Re: St. Lucie Plant Unit 1  
Docket No. 50-335  
Renewed Facility Operating License No. DPR-67

Impact of Containment Spray System Modification on Extended Power Uprate License Amendment Request

## **Supplemental Information for EPU LAR Attachment 5 Section 2.6.1 “Primary Containment Functional Design”**

**Figure 1**  
**Containment Pressure, LOCA DEHLS (Peak Pressure Response Case)**

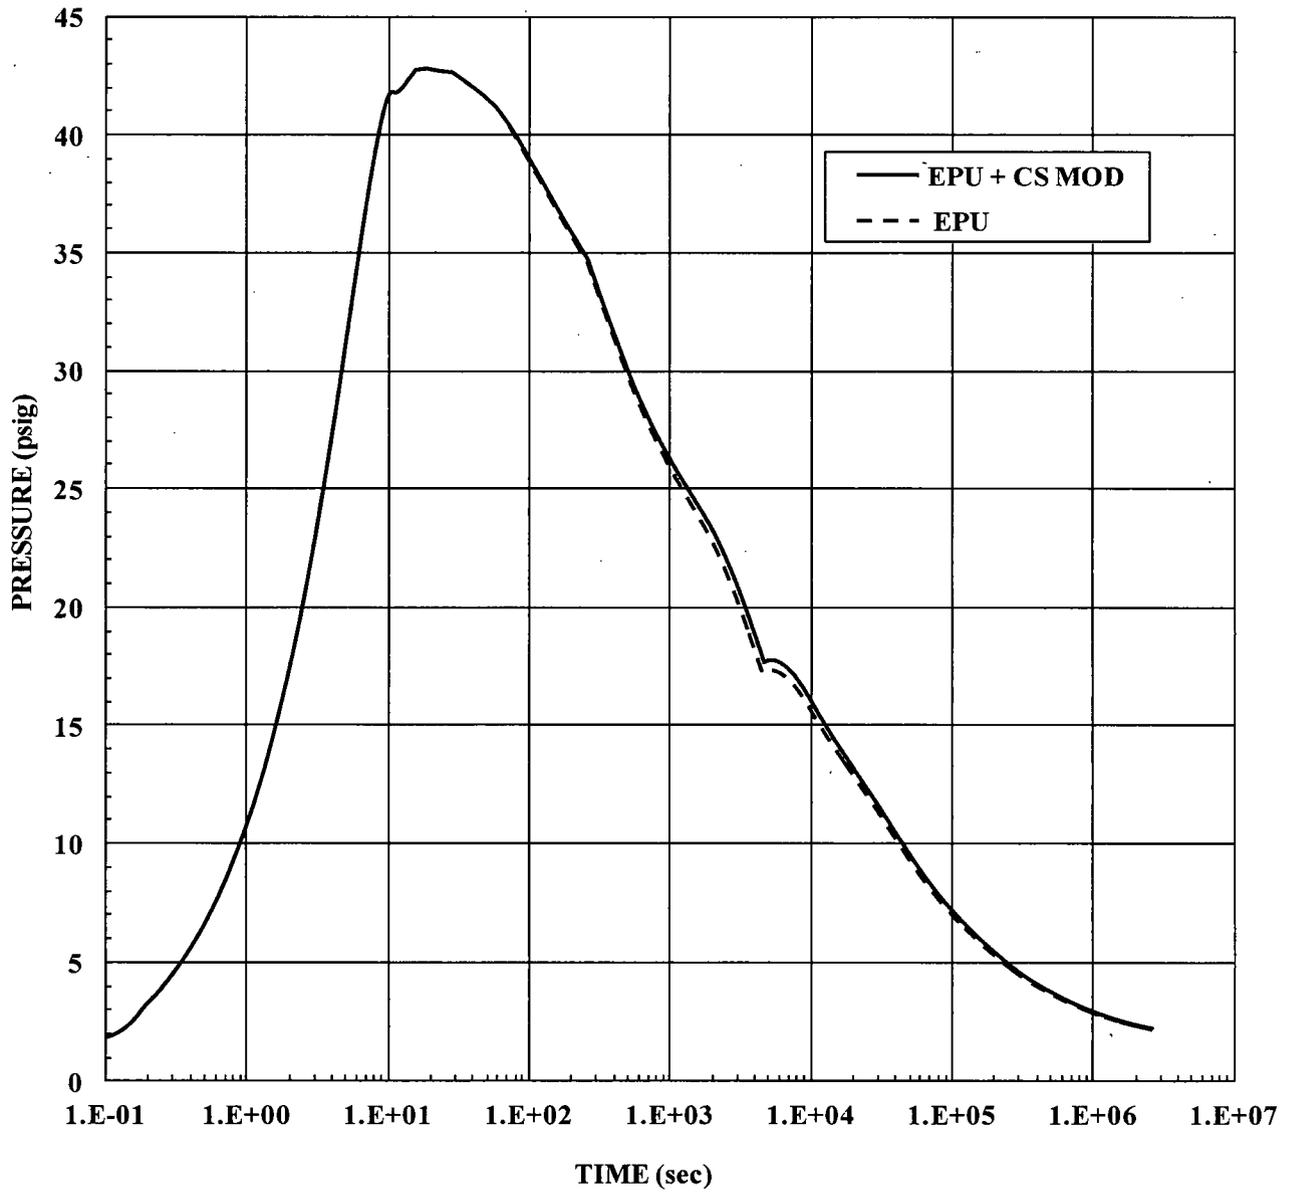
As seen from Table 3-A, the reanalysis did not result in any change to the containment peak pressure and temperature for the limiting peak pressure case (double ended hot leg slot (DEHLS) break with minimum safeguards) and limiting long-term limiting temperature response case (double ended discharge leg slot (DEDLS) break with minimum safeguards) because the peaks occurs prior to initiation of the CS flow. However, as seen from Figures 1 and 2, there was a slight adverse impact on the long-term pressure and temperature response. In addition, as seen from Table 3-B, the pressure at 24 hours increased by 0.2 psi to 7.55 psig for DEHLS and 7.64 psig for DEDLS. These values supersede the values of 7.35 psig for DEHLS and 7.44 psig for DEDLS in EPU LAR Attachment 5, Section 2.6.1.2.1.3. Also, the containment vessel liner temperature increased by 1 °F to 230 °F for DEHLS and 246 °F for DEDLS which supersede the values of 229 °F and 245 °F, respectively, in EPU LAR Attachment 5, Section 2.6.1.2.1.3. These results are as expected because the CS flow is lower and initiates later in the revised analysis.

The data in the column labeled "EPU + CS MOD" in Table 3-A supersede the DEHLS and DEDLS Peak Containment Pressure and Vapor Temperature values in EPU LAR Attachment 5, Table 2.6.1-2. The data in the column labeled "EPU + CS MOD" in Table 3-B supersede the DEHLS and DEDLS Containment Pressure @ 24 hours and Peak Containment Vessel Temperature values in EPU LAR Attachment 5, Table 2.6.1-2. Figures 1-4 supersede EPU LAR Attachment 5, Figures 2.6.1-1 through 2.6.1-4, respectively.

**Figure 5**  
**Containment Pressure – Main Steam Line Break at Full Power**  
**Failure of 1 Cooling Train**

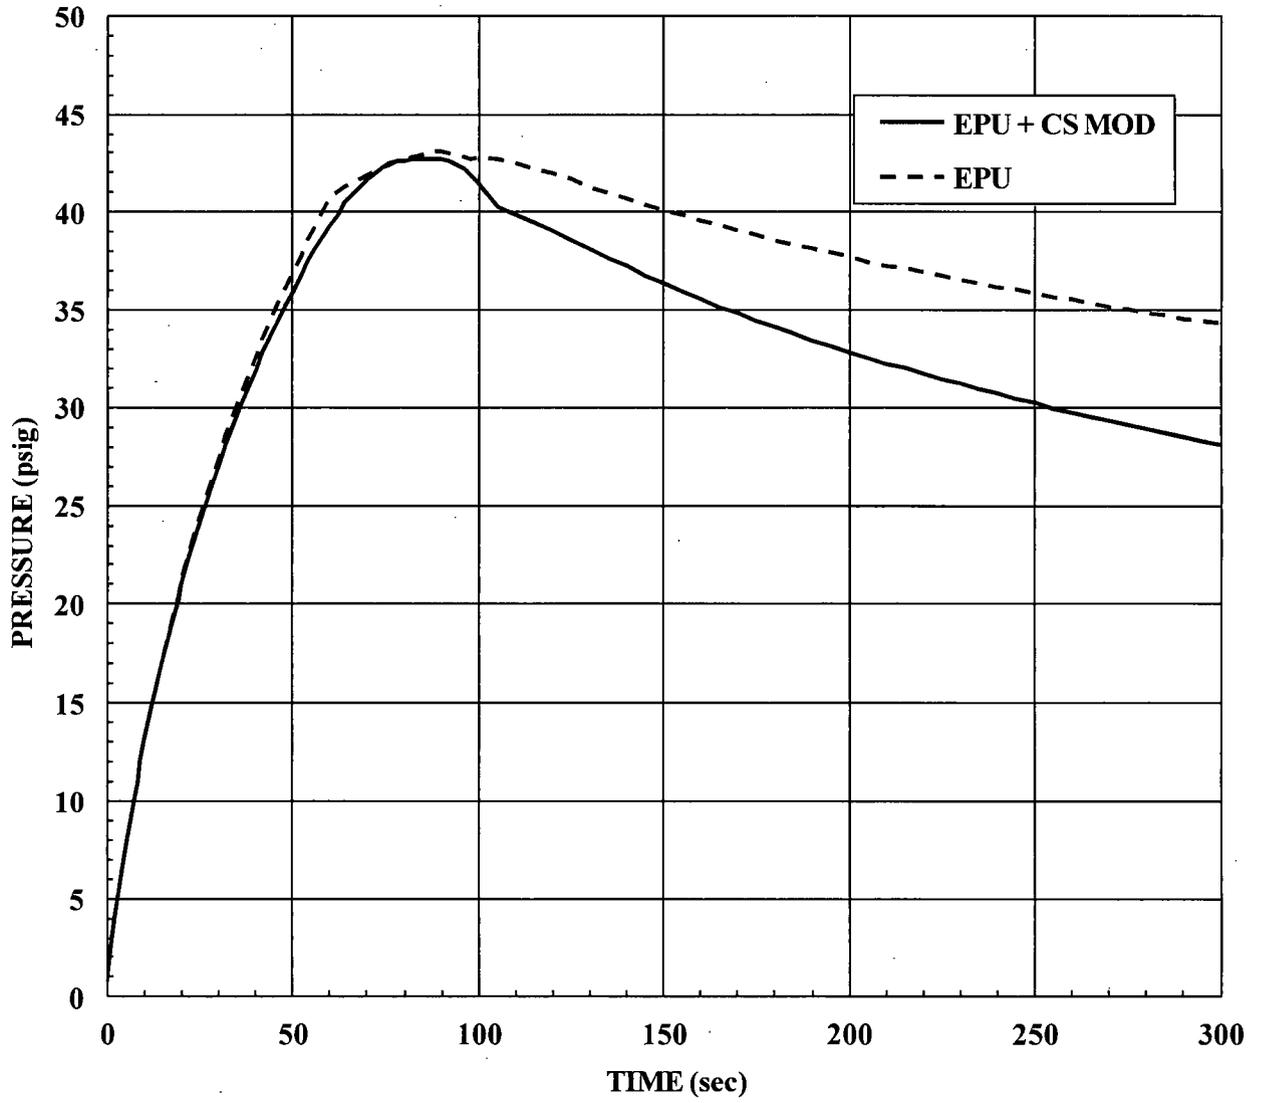
As seen from Table 4-A and Figures 5 and 6, the MSLB reanalysis resulted in a decrease in the containment peak pressure for the limiting peak pressure case (MSLB at full power with failure of 1 cooling train) and peak Equipment Qualification (EQ) temperature case. This is expected because although the CS flow is reduced, adding the containment vessel liner passive heat sink provides additional heat removal from the containment atmosphere. As seen from Table 4-A, the peak pressure decreased by 0.35 psi to 42.73 psig which supersedes the value of 43.08 psig in EPU LAR Attachment 5, Table 2.6.1-2. Also, the peak EQ temperature decreased by 11.49 °F to 387.0 °F which supersedes the value of 398.49 °F in EPU LAR Attachment 5, Table 2.6.1-2. In addition, as seen from Table 4-B, the peak containment vessel liner temperature decreases by 7.1°F to 232.3 °F. This supersedes the value of 239.4 °F in EPU LAR Attachment 5, Table 2.6.1-2.

maintained below its design temperature of 264 °F. As seen from Tables 4-A and 4-B, both of these acceptance criteria are met. Figures 5 and 6 supersede EPU LAR Attachment 5, Figures 2.6.1-5 and 2.6.1-6, respectively.

**EPU LAR Figure 2.8.5.6.3-14**  
**Boric Acid Concentration in the Core versus Time**

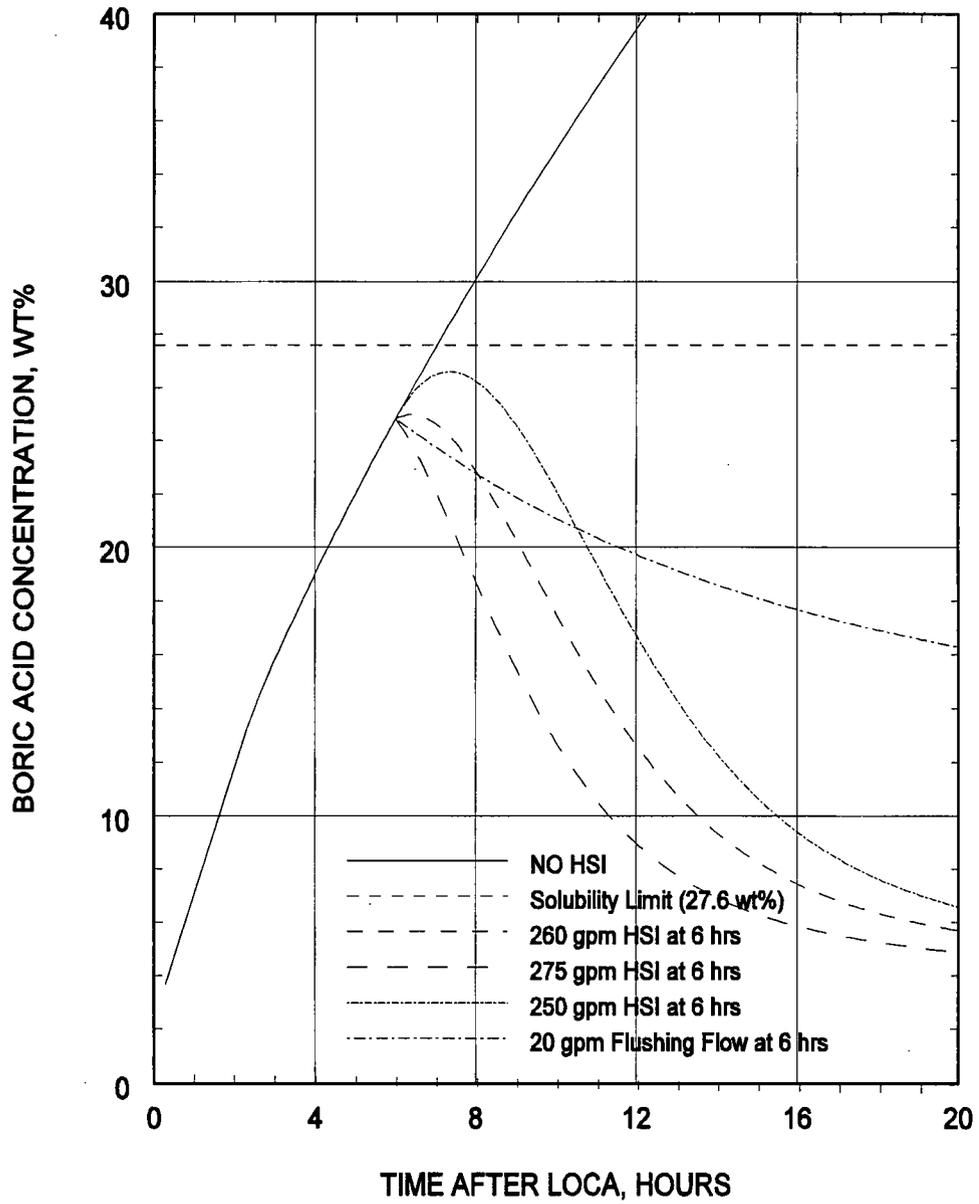
The boric acid precipitation analysis was revised to address the revised input conditions documented above and the revised results were evaluated against the previous EPU evaluations. The reanalysis only saw a change in the results of one case, which was the case with 250 gpm of hot side injection initiated at 6.0 hours post-LOCA. The time for maximum boric acid concentration for this case decreased by 0.1 hours, from 7.4 to 7.3 hours. The maximum boric acid concentration continues to be 26.6 wt%, which is less than the solubility limit of 27.6 wt%. Therefore, the proposed EPU remains acceptable with the revised EPU boric acid precipitation analysis.

Based on the above changes due to the updated CS flow rate, the following changes are made to EPU LAR Attachment 5, Section 2.8.5.6.3.5. Entries are updated in EPU LAR Attachment 5, Tables 2.8.5.6.3-10 and 2.8.5.6.3-11, and EPU LAR Attachment 5, Figures 2.8.5.6.3-14 and 2.8.5.6.3-15 are replaced. These changes and updates are shown in the Tables and Figures below. Note that the tables are not reproduced in their entirety; only the information that is updated is shown below.
